Subsidence Management Services

Response to Camden Council by Innovation Property (UK) Ltd, June 2016
96 Haverstock Hill (our reference: IFS-AVI-SUB-14-0052426)

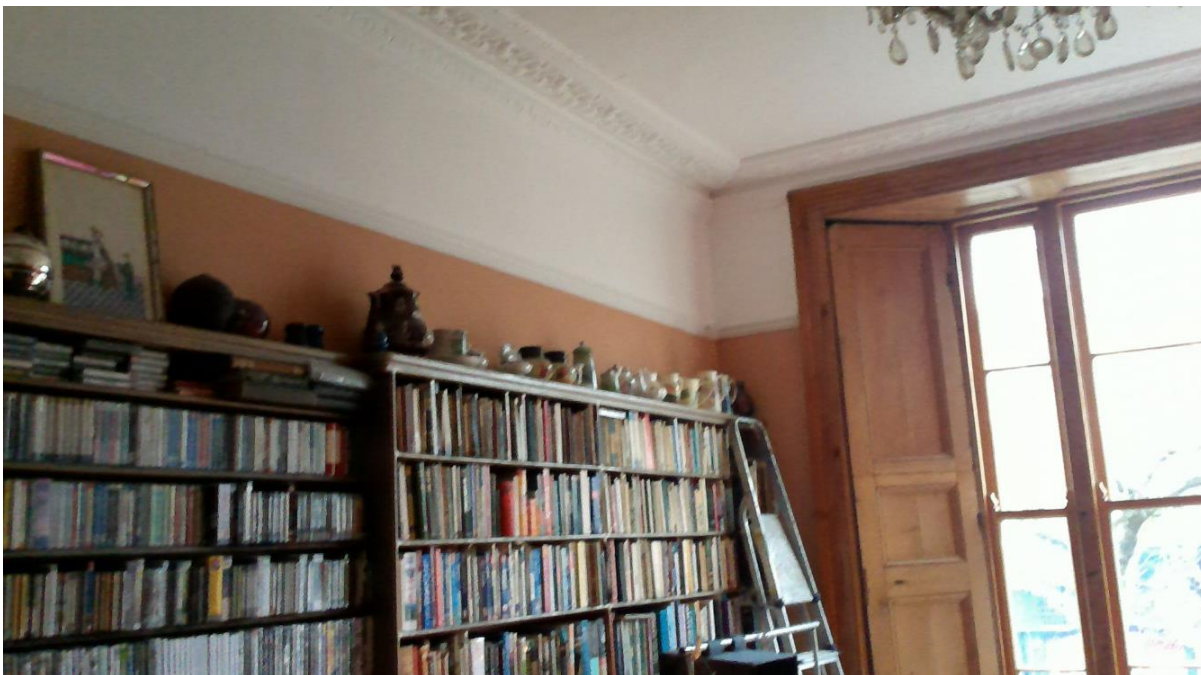
1.1. The reports that you have provided to Camden Council do not discuss any external cracking, please could we have an explanation for this, as this is quite unusual.

We have noted a number of areas of external crack damage to both the front and rear of the property. During the recent site meeting with the local authority officers, we noted areas of new crack damage to the front elevation of the property to the right side of the front entrance steps, driveway boundary wall and exterior entranceway to the Garden Flat. We consider this is in keeping with foundation related movement i.e. subsidence.

This is less severe than the damage to the interior of the property, however it is evident from the monitoring that has been carried out that the majority of the front elevation has experienced relatively uniform seasonal movement, the exception being point 4 on the front right corner. Where movement is uniform, regardless of magnitude, then cracking does not occur.

We are also of the opinion that the previous scheme to stabilise the front entrance steps located on the right side of the building utilising a number of piles (Shire Piling) has in part resolved the subsidence movement but not prevented the internal areas of the property being affected by root induced clay shrinkage subsidence. This is supported by greater external damage being observed further away from the steps, such as to the driveway boundary wall and exterior entranceway to the Garden Flat.

The scheme of piling to the front entrance steps has not provided a barrier to prevent tree roots from affecting the shrinkable clay sub soil beneath the building foundations internally to the property.
